Service Bulletin No. 198

SUBJECT: Replacement of Tail Brace Clevises

MODELS AFFECTED: PA-22-108 Colt Aircraft - Serial Nos. 22-8000 to 22-8042 inclusive

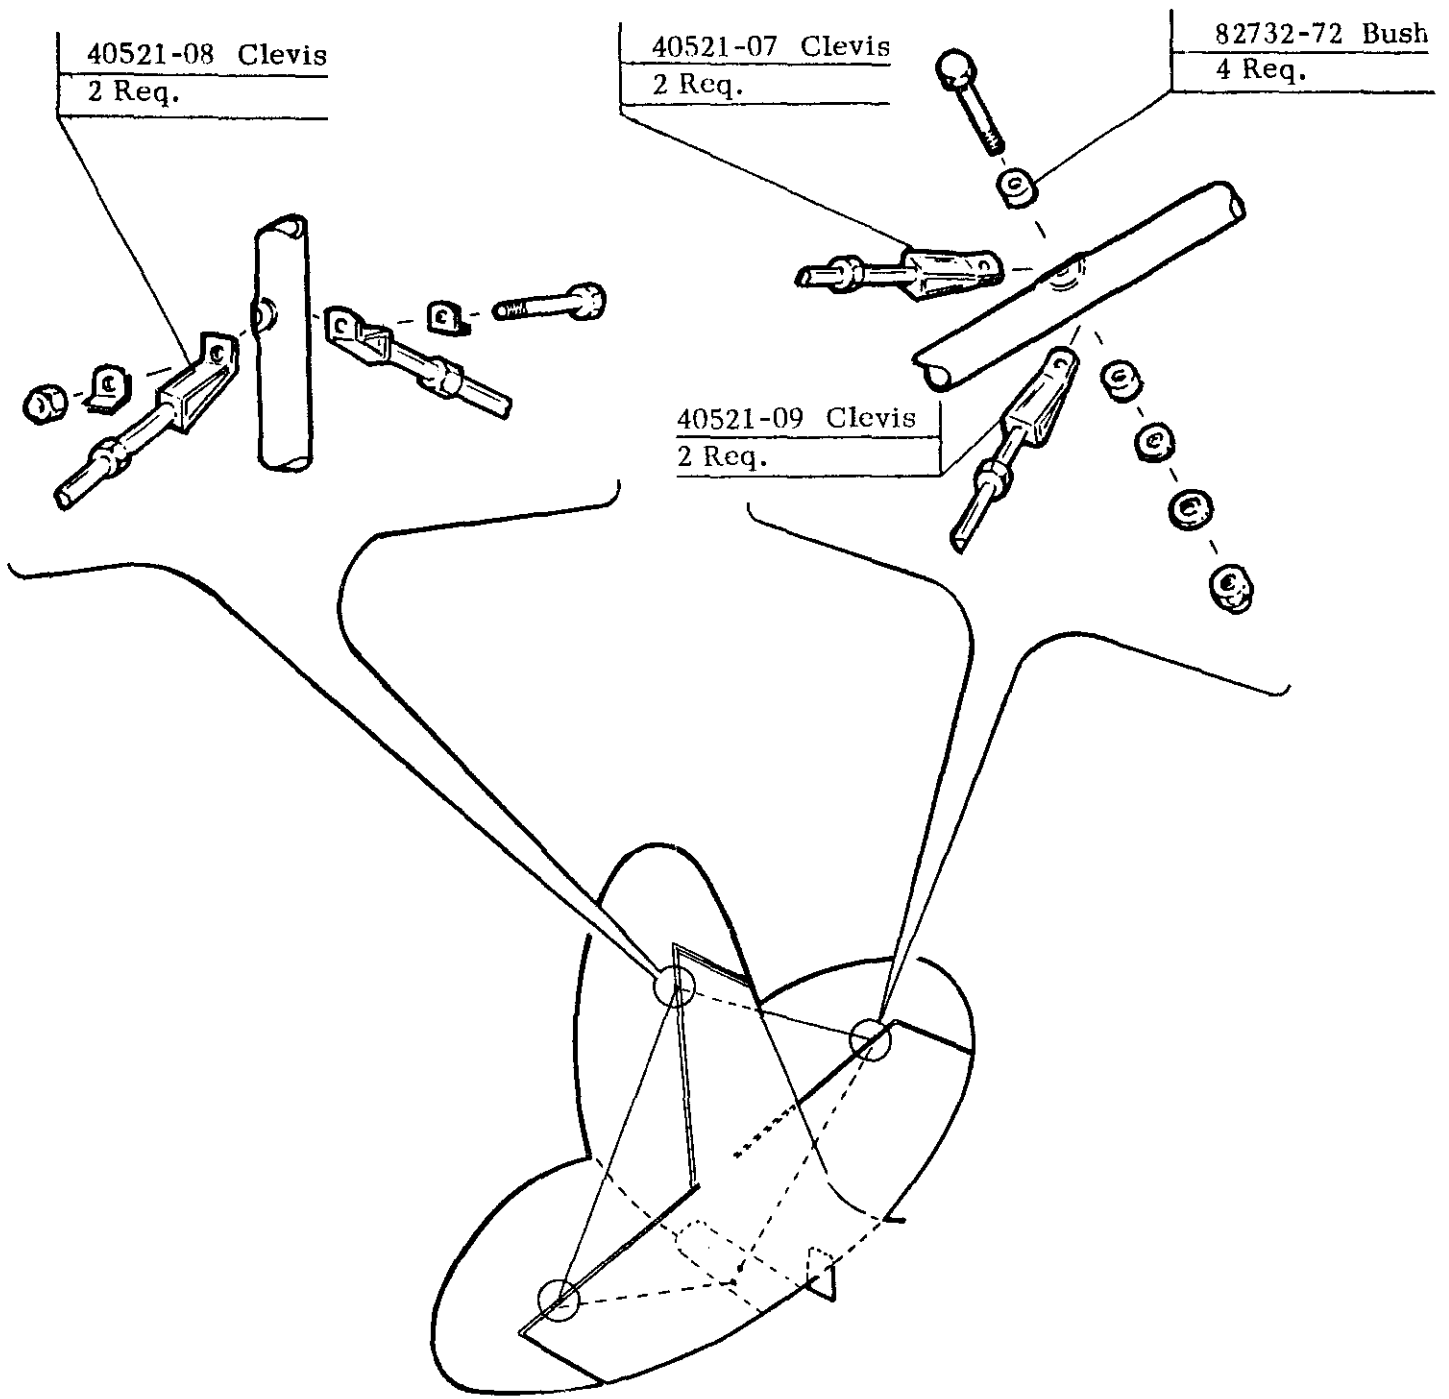
The tail brace clevises and bushings on the aircraft indicated by the above serial numbers are to be replaced.

The sketch on the reverse side of this Service Bulletin will indicate the location of the clevises and bushings to be changed.

Kit No. 754 381, consisting of six (6) clevises and four (4) bushings to comply with this Service Bulletin, will be forwarded by automatic factory distribution. The kit will be provided on a no charge basis. A compliance card is furnished with the kit for this modification. This card must be signed and immediately returned to the factory.
